ORIGINATION FORM

Proposed Revisions to a Standard Plans Index

Index Number: 455-002

Index Title: SQUARE PRESTRESSED CONCRETE PILE SPLICES

SPLICE AFTER BONDING
DRIVABLE PREPLANNED
PRESTRESSED PRECAST
PILE SPLICE DETAIL

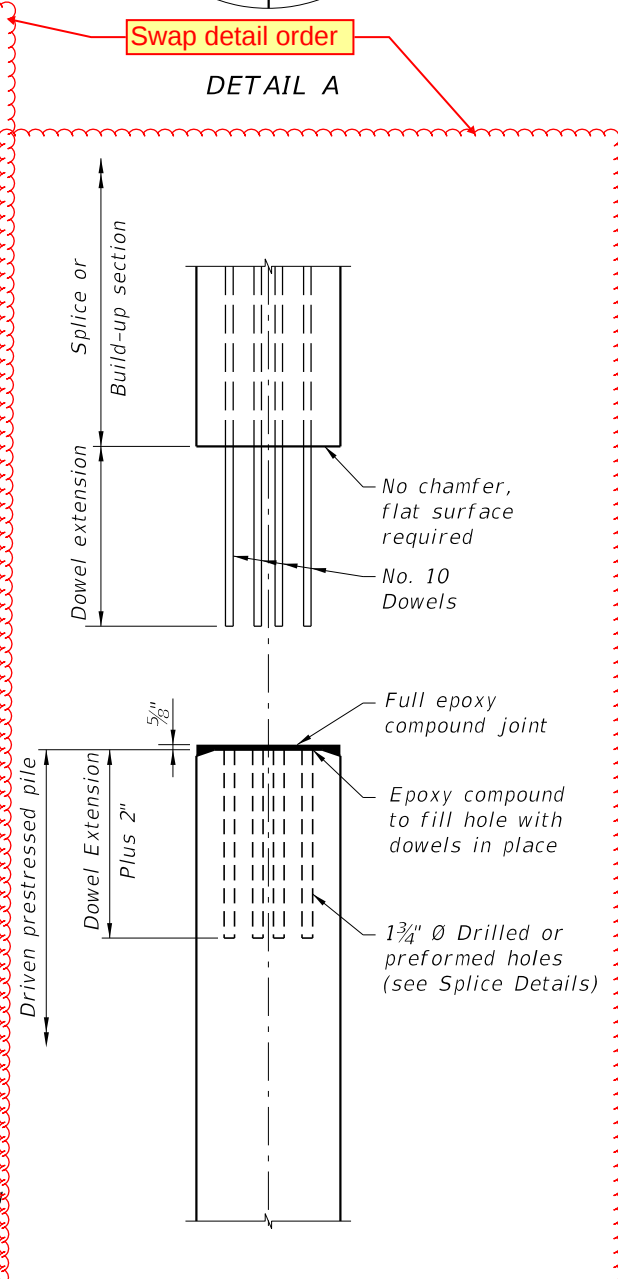
TYPICAL SPLICE
BEFORE BONDING

Move to center under details
